ALERT SERVICE BULLETIN

Subject: Warning decal, cargo hook load ring

Document Number 159-003-00

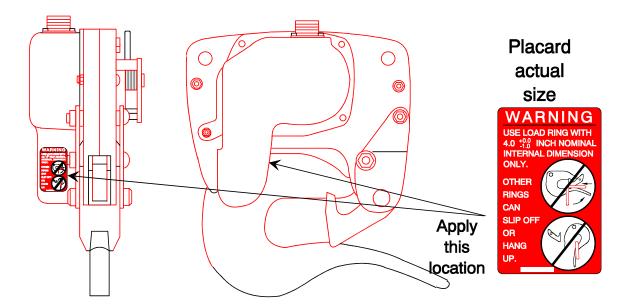
- 1. Prepare the helicopter for maintenance.
- 2. Remove grease and dirt on the cargo hook in the area shown in the diagram by cleaning the surface with isopropyl alcohol or its equivalent.
- 3. Remove the adhesive backing from the warning decal and affix it to the hook in the assigned location.
- 4. Apply finger pressure to ensure good adhesion.
- 5. Insert a copy of Onboard Systems document 121-001-00 as manufacture's data, into the back of the BHT Flight Manual Supplement.
